Construction Change Directive

PROJECT: *(name and address)*
Highland Township Fire Station 2
PIA #18-122B

CCD INFORMATION:
Directive Number: 001
Date: July 13, 2021

“EXHIBIT A” – CCD NO. 1

M1-02 FLOOR PLANS – DOMESTIC WATER

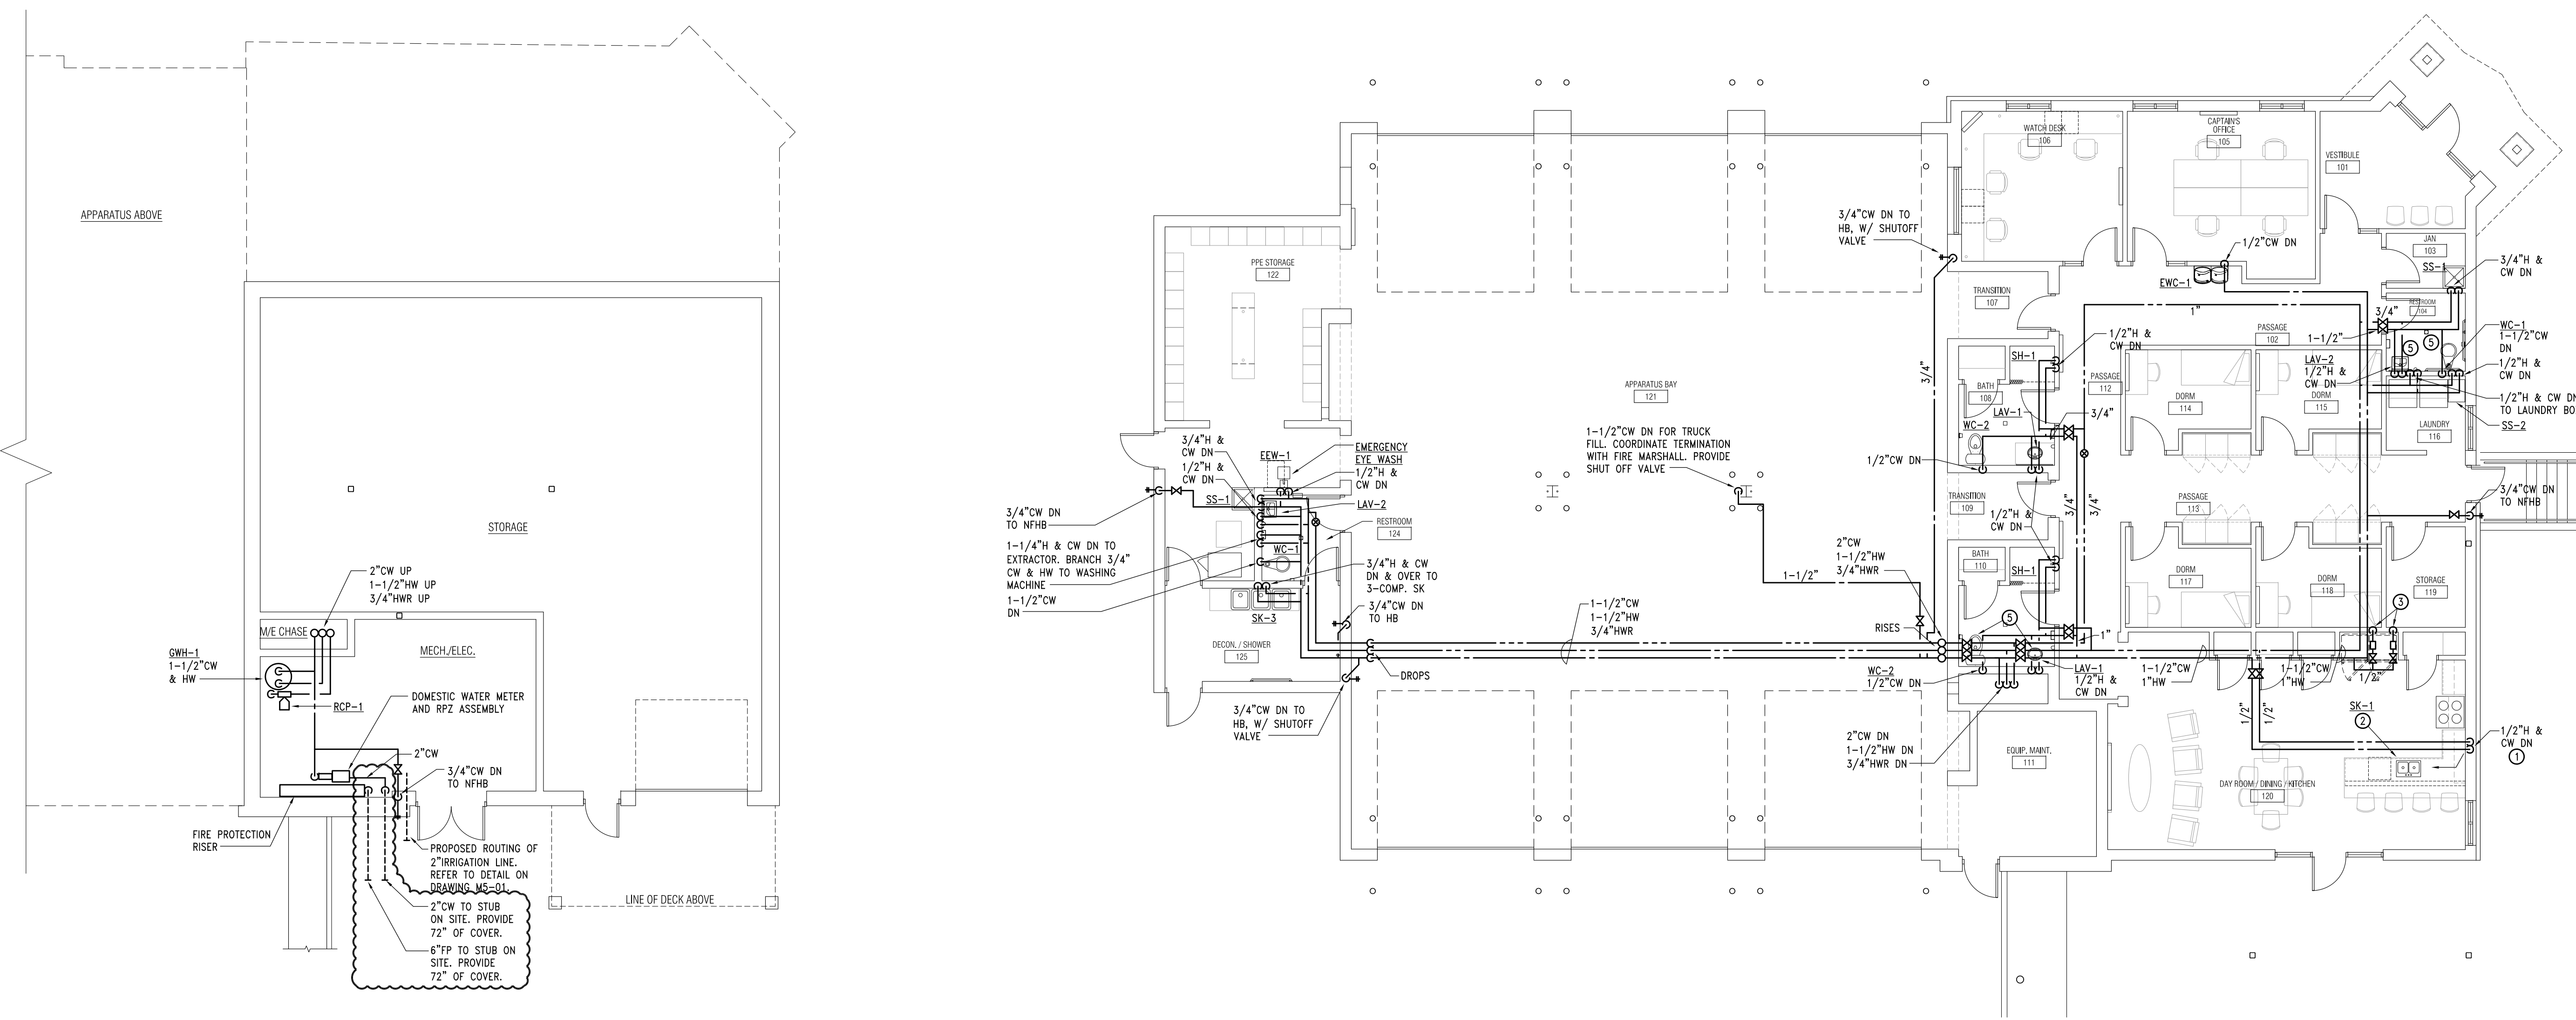
- A. Delete one feed water stub and provide two feed water stubs. One for fire protection and one for domestic water.

M3-01 FLOOR PLANS - PIPING

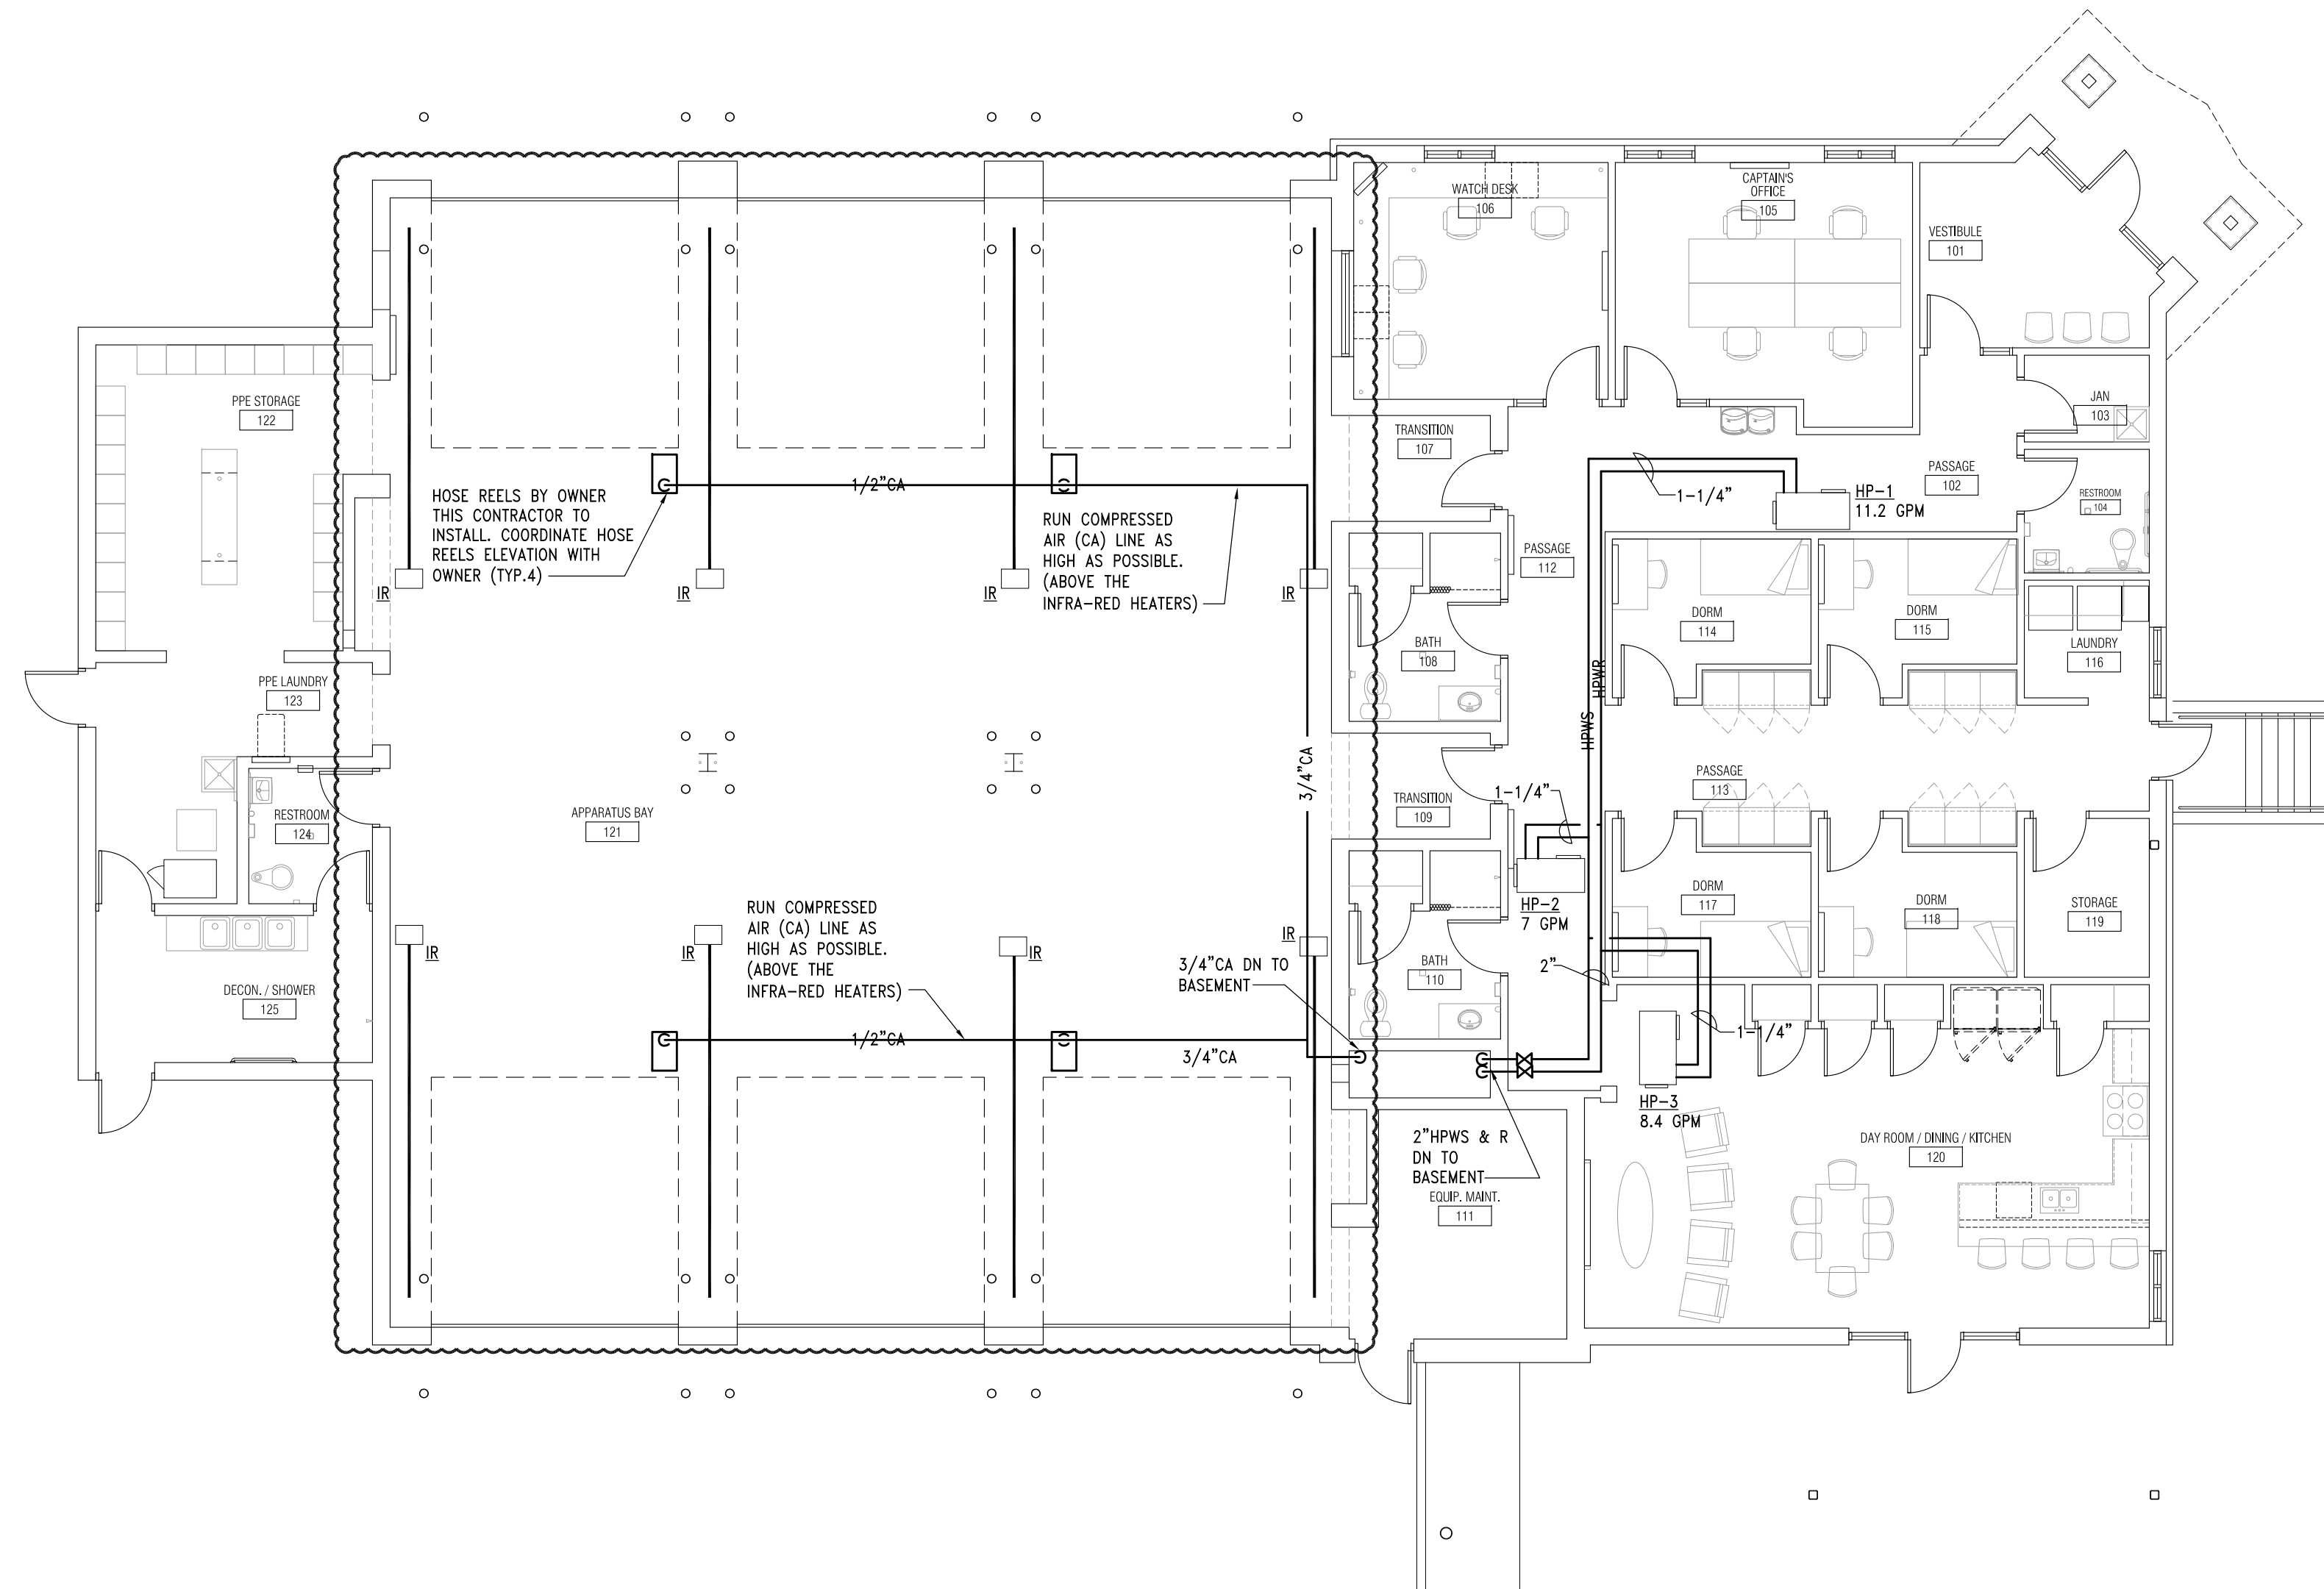
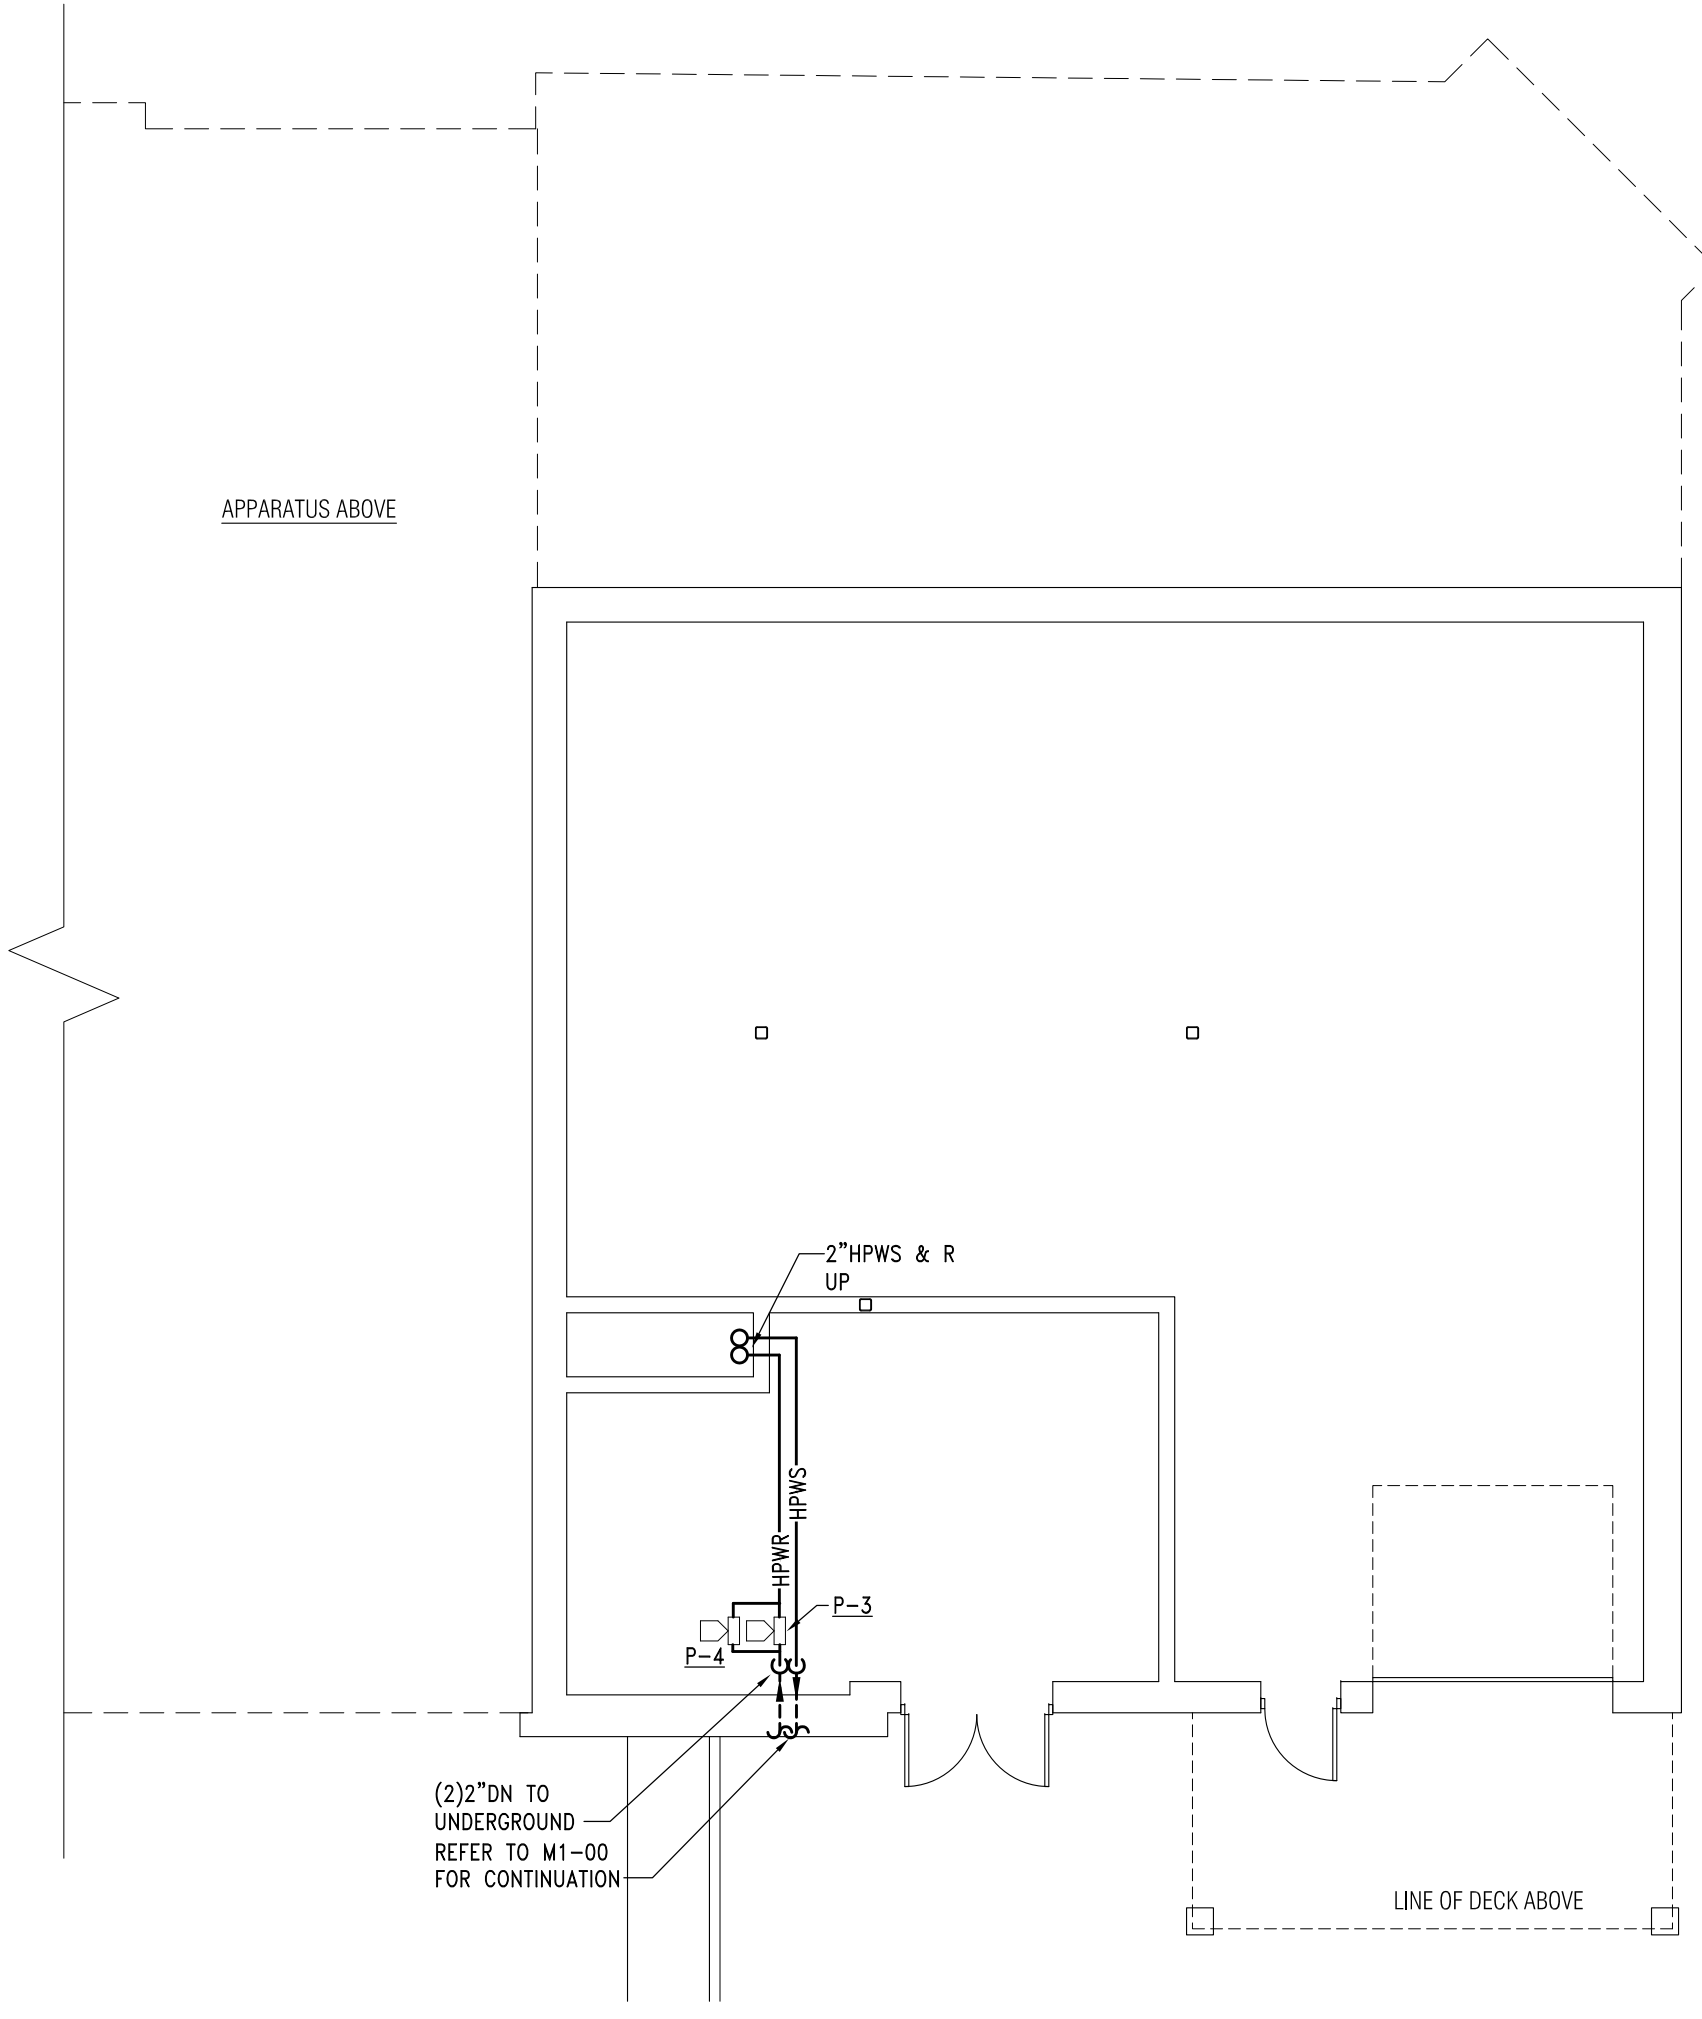
- A. Add compressed air piping with hose reels as indicated.
